LOCATION: St. Augustine Drive, north of Elam Road.

APPLICANT/OWNER: Yesenia Hernandez

REQUEST: An application to create one 0.67-acre (29,241-square foot) lot from a tract of land in City Block 6669 on property located on St. Augustine Drive, north of Elam Road.

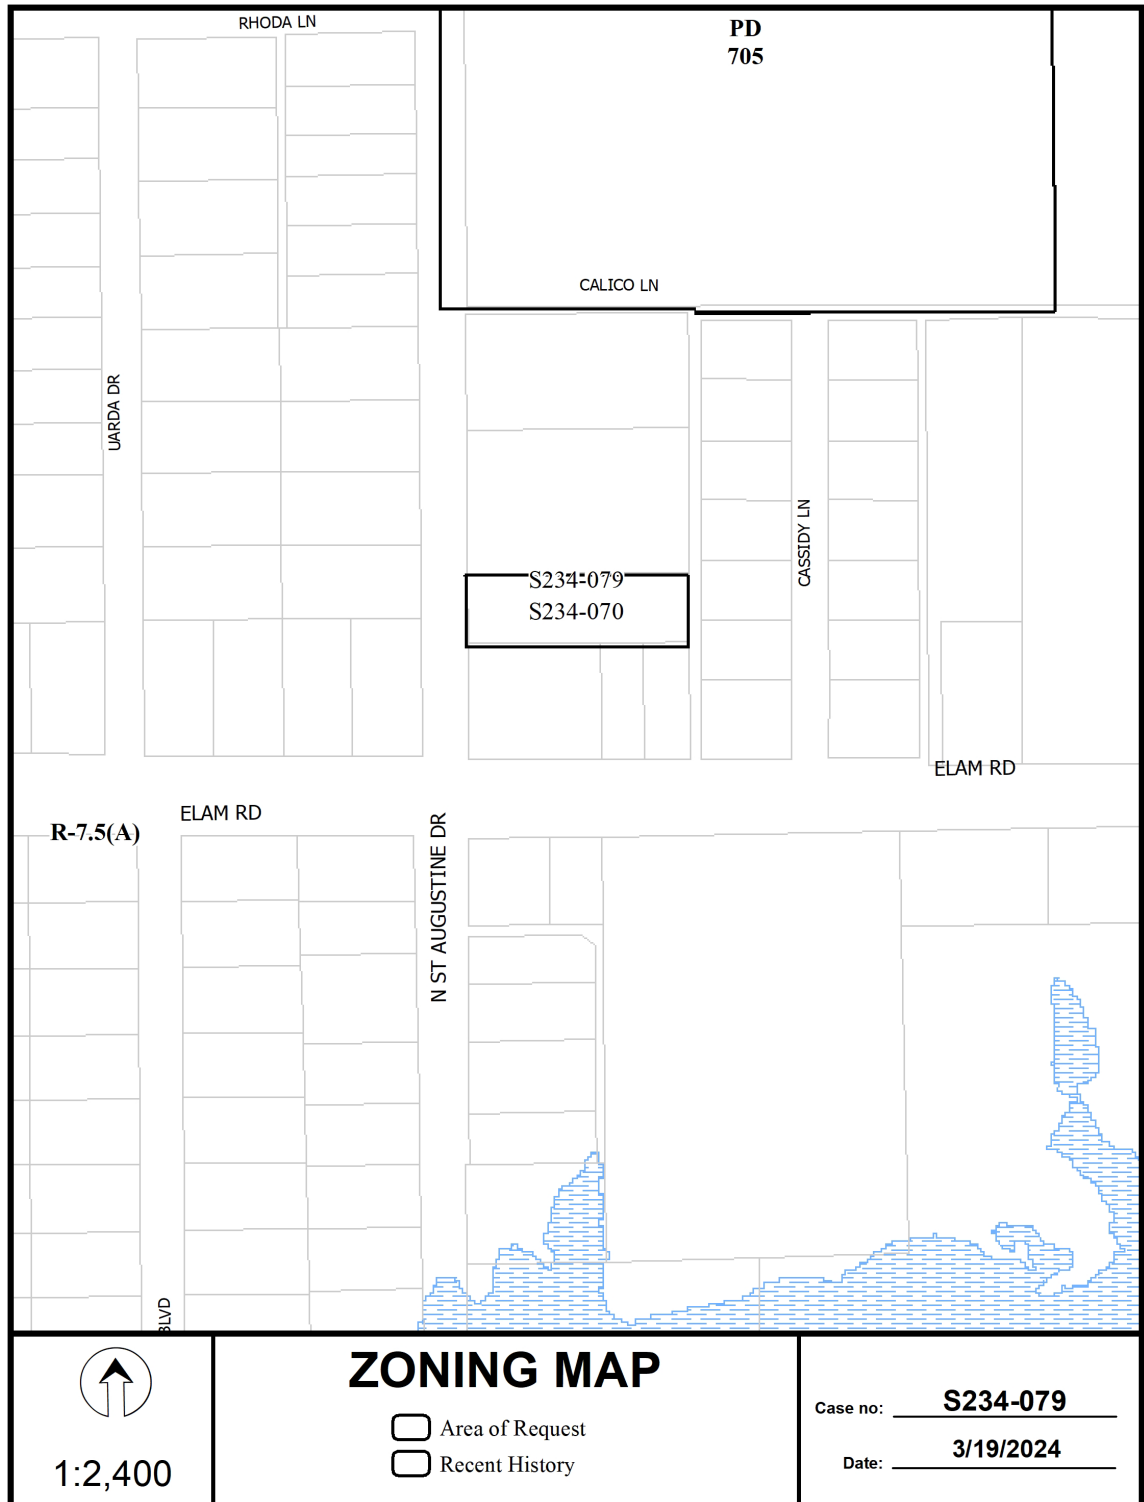
16. Prior to final plat, submit a completed final plat checklist and all supporting documents.
17. On the final plat, show how all adjoining right-of-way was created. Section 51A-8.403(a)(1)(A)(xxii).
18. On the final plat, show distances/width across all adjoining right-of-way

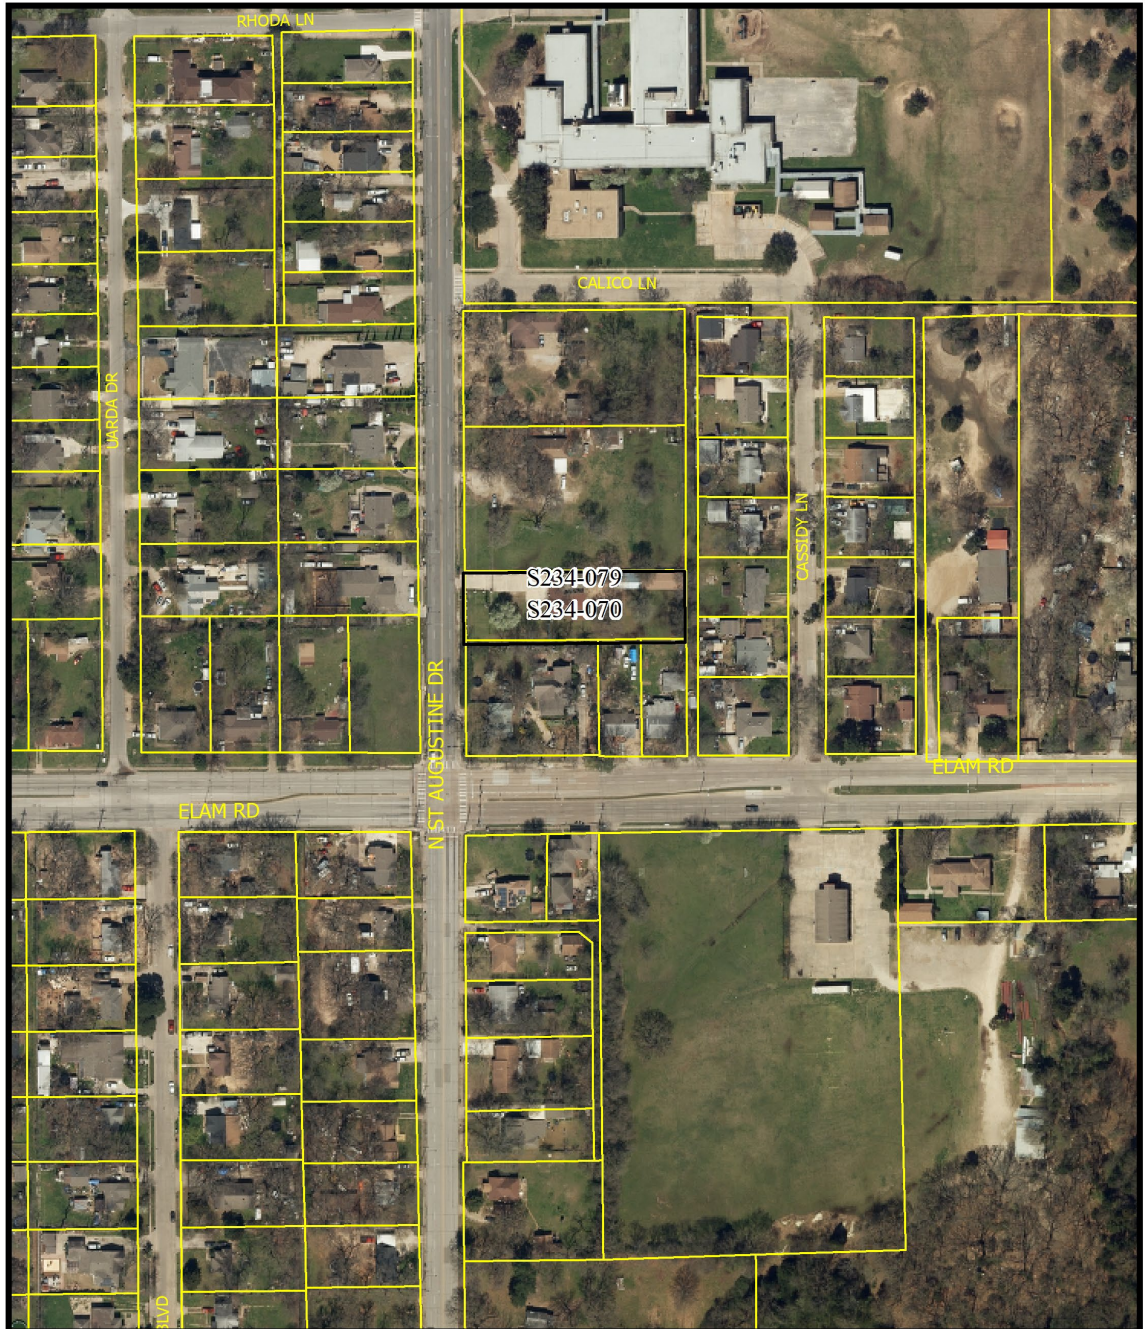
19. Prior to the final plat, please contact Real Estate division and confirm fence in the alley is not encroaching into the alley.
20. Prior to the final plat, change "St. Augustine Road" to "St. Augustine Drive".
21. Prior to the final plat, change "Cassidy Street" to "Cassidy Lane".
22. On the final plat, identify the property as Lot 1 in City Block B/6669.
